Permit No: 0011829
Insp Area: 2

Site Address: 1832 FLORIN RD SAC
Parcel No: 047-0041-006

Nature of Work: REROOF T/O 31 SQ INSTALL TILE

Subject: Structural Investigation Report of the Roof for the Residence located at 1832 Florin Road,
Sacramento, CA 95822.

ROOF PLAN - KENNEDY

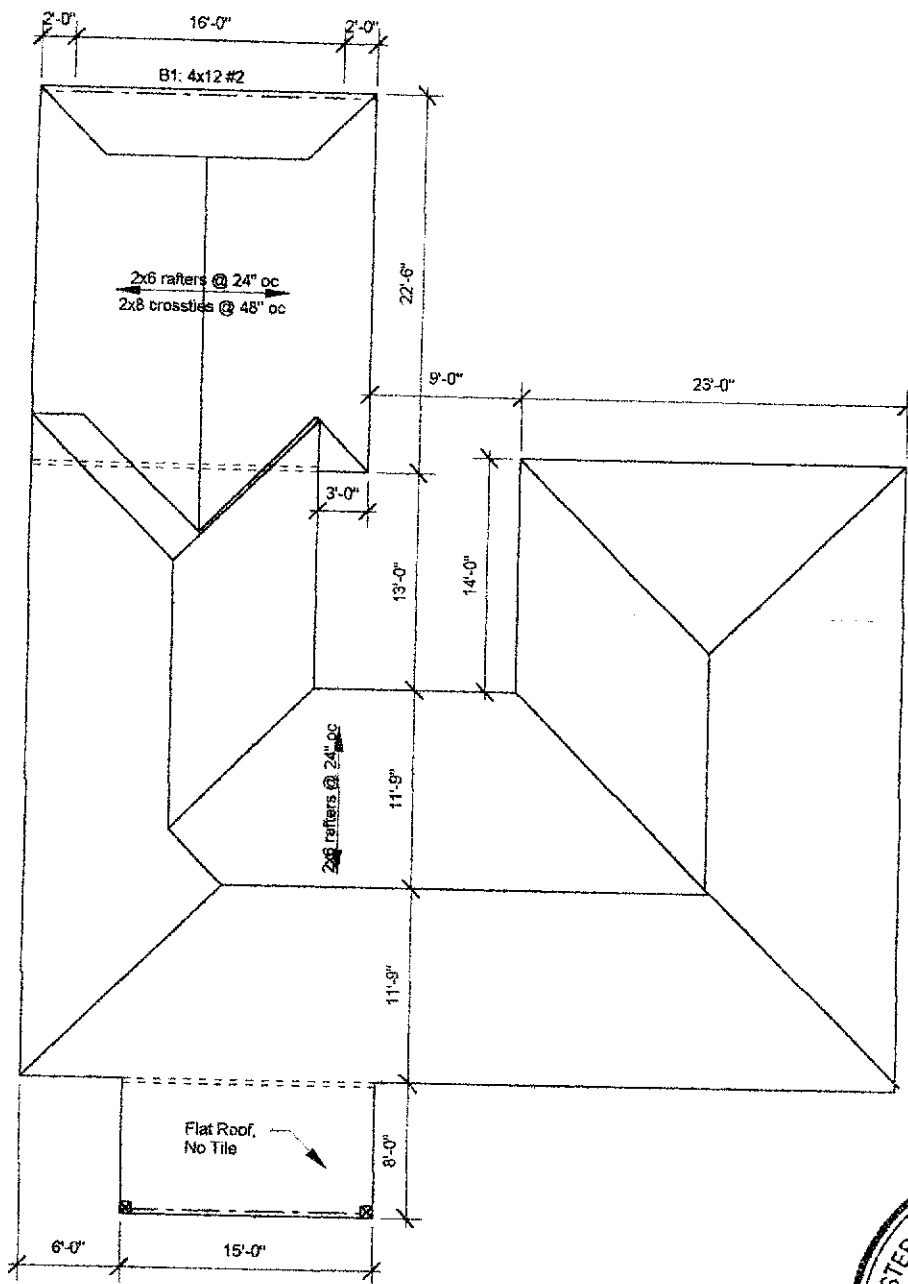
UBC Requires the collar ties to be as low as possible to the ceiling joists. Verify in field.

1/6 See roof framing plan, sheet 6.
